STAFF REPORT 08-14-2024 REGULAR MEETING

APPLICATION NUMBER: HDC2024-00357

ADDRESS: MULTIPLE LOCATIONS IN THE PUBLIC RIGHT-OF-WAY

SCOPE: REPLACE STREETLIGHTS

Spec sheet for proposed poles, as provided by the applicant (PLA).

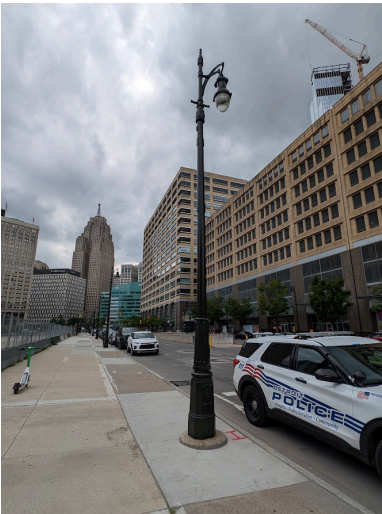
These poles, found at Harmonie Park, appear to be older versions of the stresscrete "Belmont" poles proposed in this application. In staff's opinion, the simpler design and elegant stature of these units is superior to the aggressively false historicism and gaudy appearance of the fiberglass poles. Staff photo, August 8, 2024.

- In contrast to the current fiberglass poles, staff assesses that the proposed stresscrete poles are a substantial upgrade, not only in quality but also, to some extent, in compatibility with the districts. Although not a replication of the original “Detroit design” PLC bishop poles, they do not make the error of the existing poles introducing a discordant historic vocabulary into the district. The proposed pole has elegant lines suggestive of early 20th century prototypes, but does not try to inject falsely historic ornamentation into the district. As such, staff is hopeful that it will exist quietly as an element in the district, neither detracting from, or contributing to, the authentic historic context.

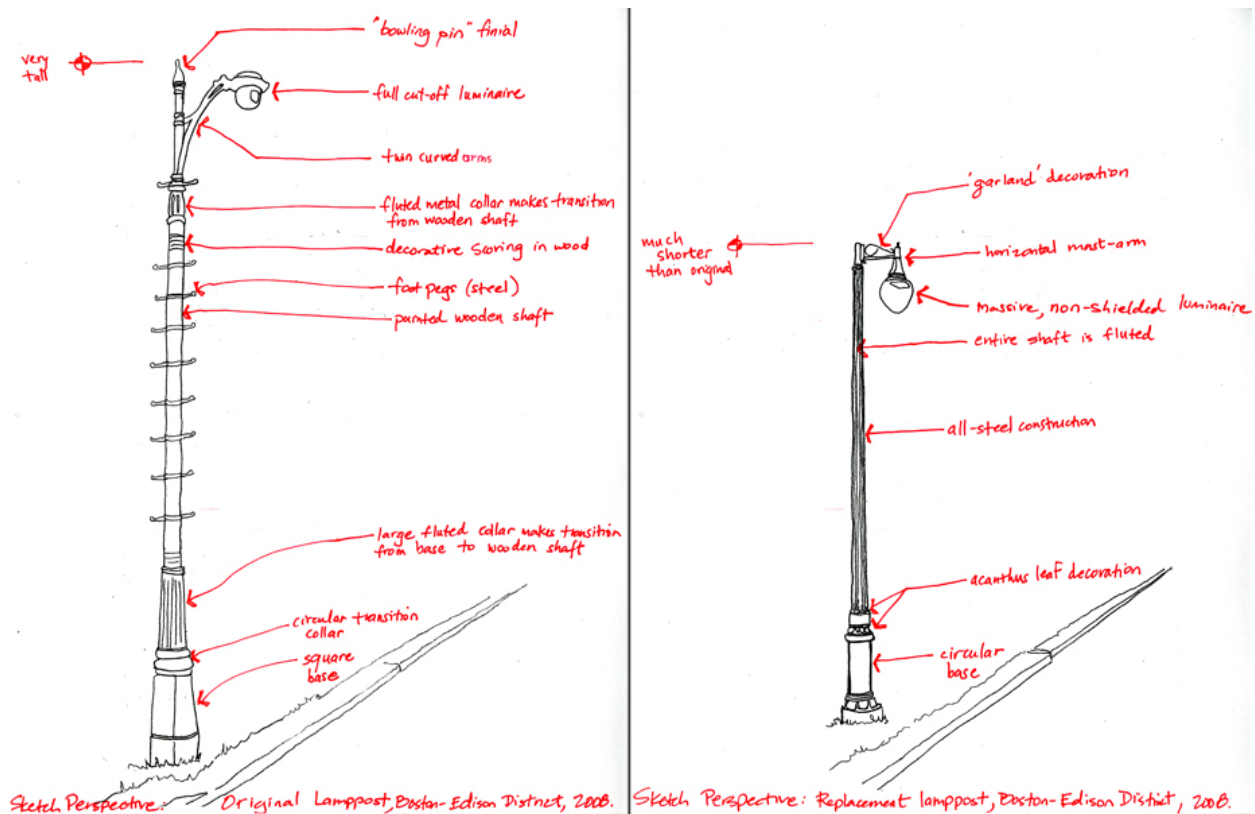
- As to the question concerning specifying PLC “bishop”-style poles, the PLA (applicant) provided the following response for your consideration:

The Issue with using the PL / Bishop poles is the cost, the PLA could simply not afford to do the project with its current budget. The project would cost about \$6million and the labor cost would be about another \$1million. The PLAs budget is \$10million a year to keep 67,000 street lights working, 70% of the PLA budget on 611 lights is something that we cant do.

Below is the break down of the cost of each option.

The current proposal Pole and fixture total cost is 2769.64 for each unit, at 611 units would \$1,692,250.04

A replication pole, we call it a comerica pole is costly, first is \$549.00 for the foundation, \$1065.33 for the arm, the pole is \$6,586.67 and the fixture is \$1,539.00. Also take into account a lot more labor is needed to install these that cost would be higher as well. The unit price for a Comerica pole comes to \$9,740 for each unit, at 611 units would be \$5,951,140 just for material.
